# CITY OF ALBUQUERQUE

January 30, 2024

RE: **Lot 21 Block 1 Unit 27 Unit 27  
5505 Valiente Rd. NW  
Volcano Cliffs Subdivision  
Grading and Drainage Plan  
Engineers Stamp Date 5/19/2023 (C11D009)  
Pad Certification Date: 1/24/2024**

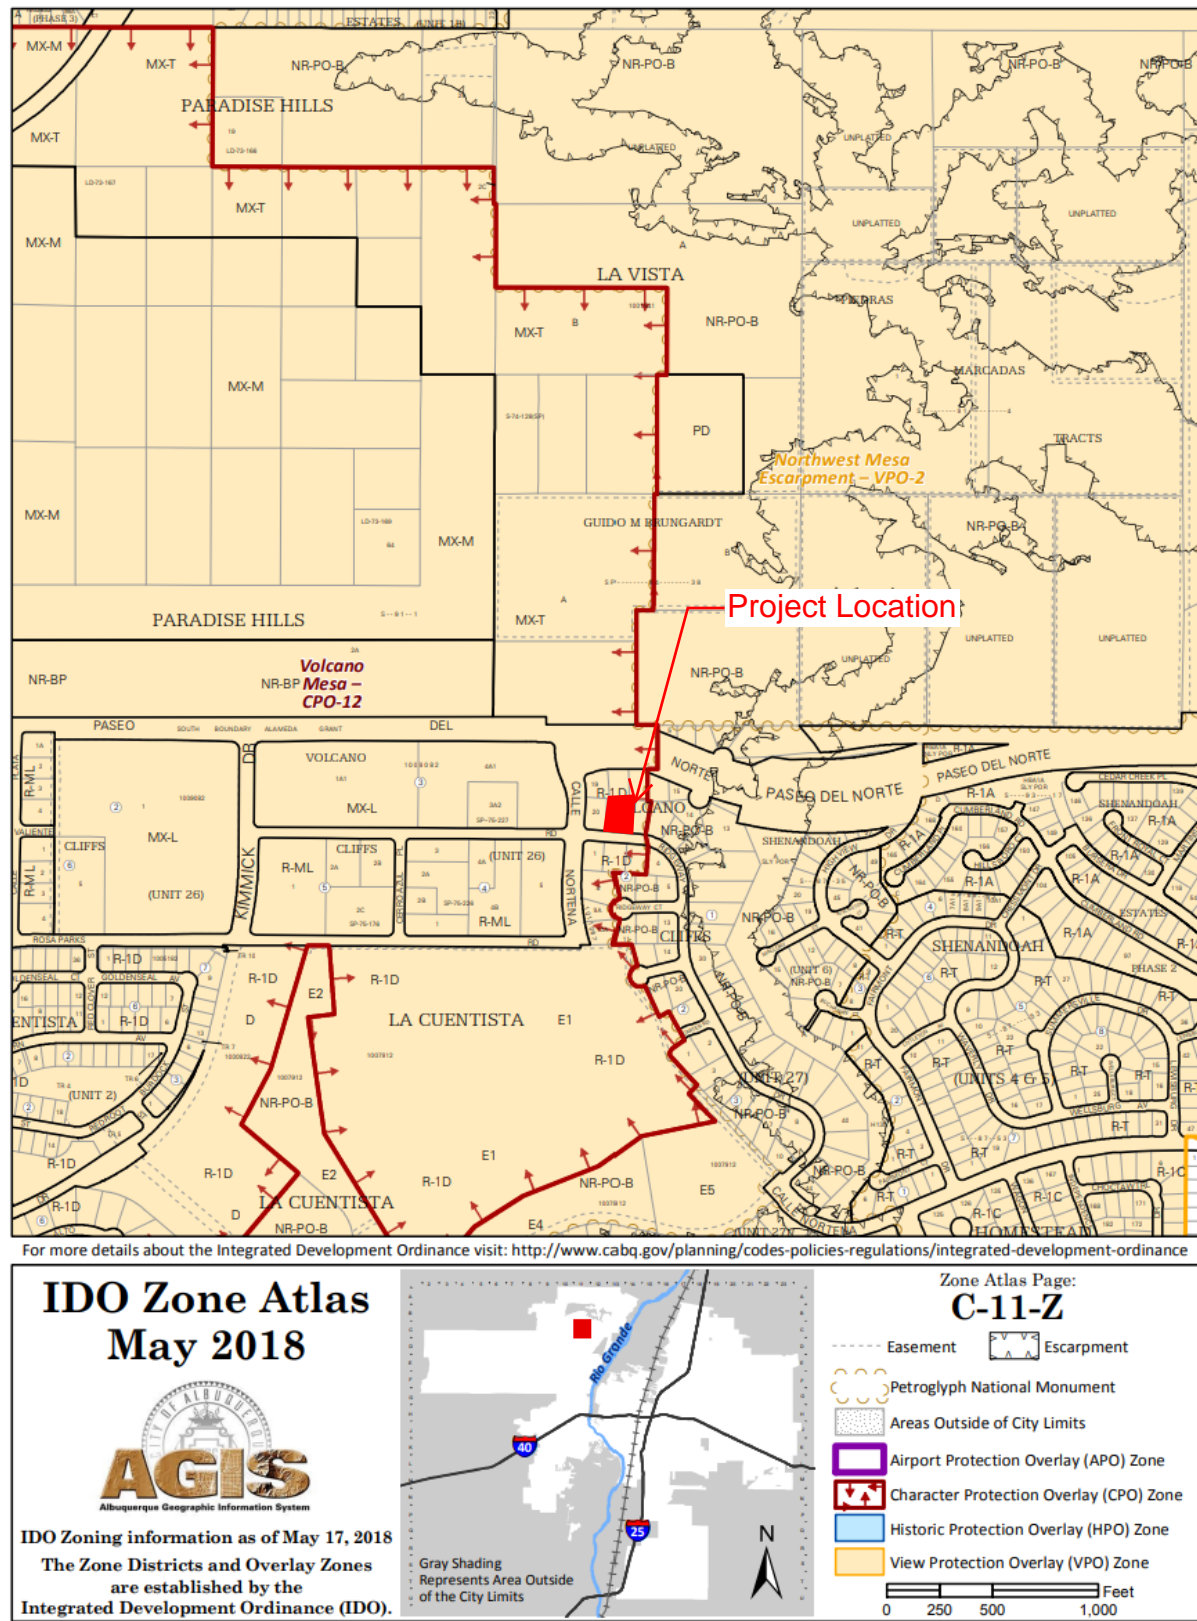
**Advise the owner contractor not to use dirt as a ramp to climb the curb, use lumber or crusher fines for this purpose. Place this note on the plan.**

**Reiterate to the Owner/Contractor that a separate permit for a garden/retaining wall must be obtained with the approved G&D plan and Pad Certification. Also, if a swimming pool is to be placed after this approval a new grading and drainage plan will need to be resubmitted showing the changes for the land treatments.**

**Prior to Certificate of Occupancy release, Engineer Certification per the DPM checklist is required.**
